In the United States Patent and Trademark Office

For: Self-Route Expandable Multi-Memory Packet Switch with Distributed Scheduling Means

Serial Number: 09/683,429

Response and Amendment Under 37 C.F.R. §1.111
And Petition for One Month Extension of Time Under 37 CFR 1.136(a)(1)

FIG. 3

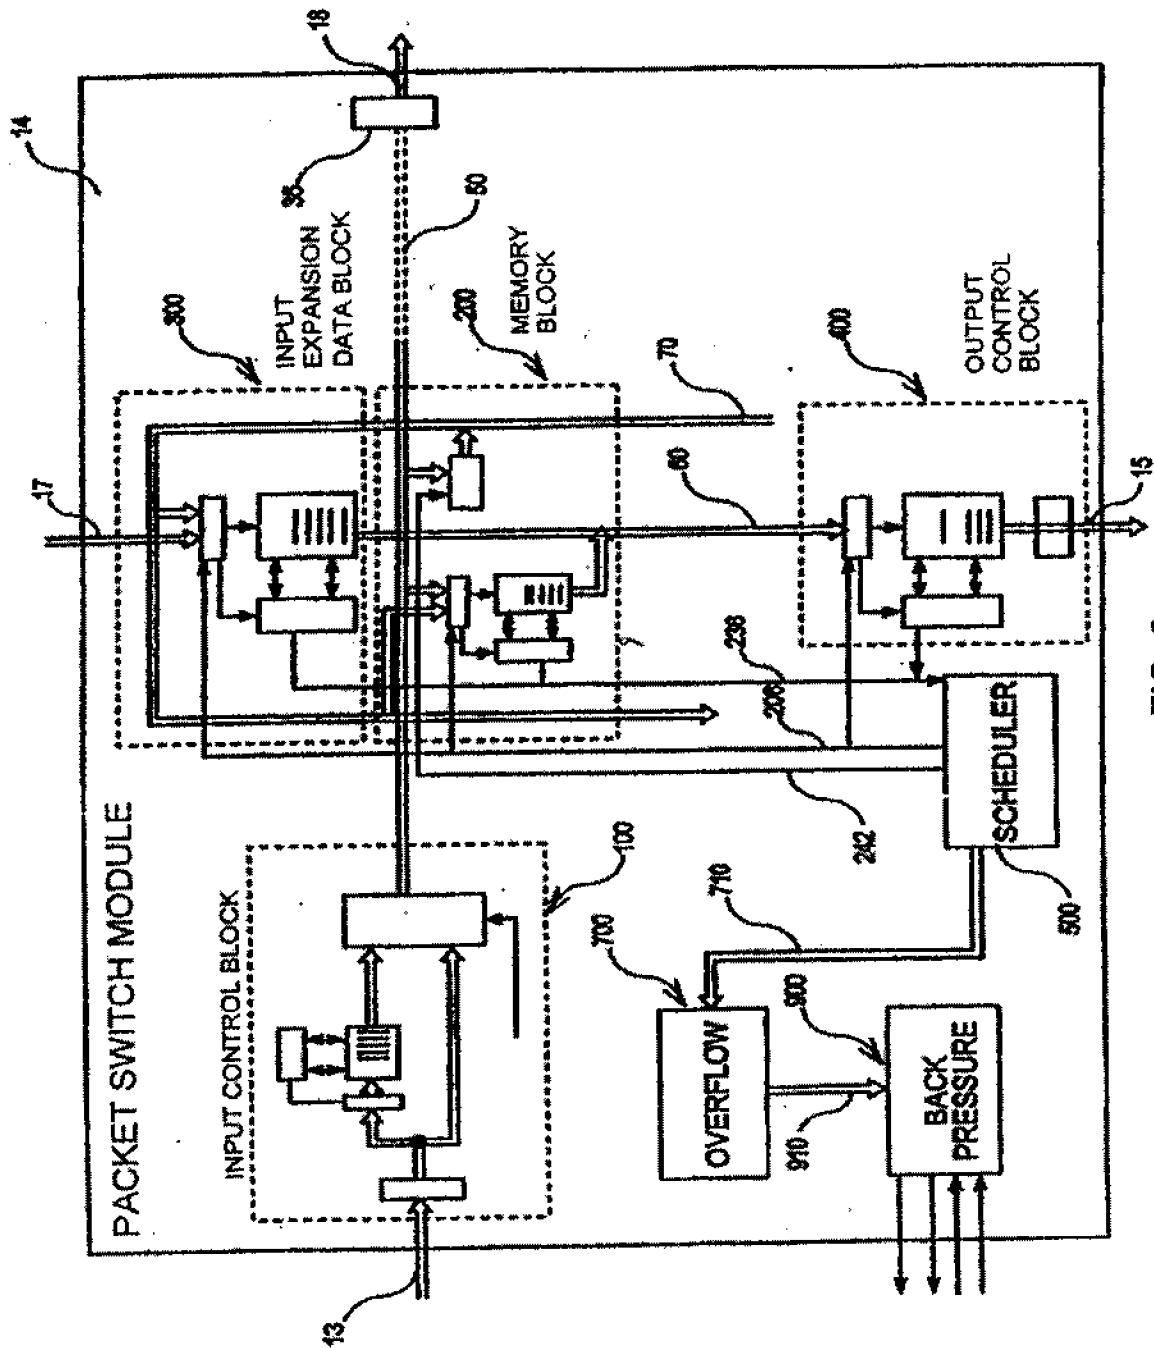
The Office Action stated an objection to Figures 3-8 as failing to comply with 37 CFR 1.121(d) because descriptive labels necessary for understanding the drawings are missing. The Office Action also stated that the quality of the connections shown on Figure 8 is not acceptable. A proposed set of drawings to overcome the objections is attached to this amendment as Appendix A. Each sheet has been labeled "Replacement Sheet" to be in compliance with 37 CFR 1.121(d).
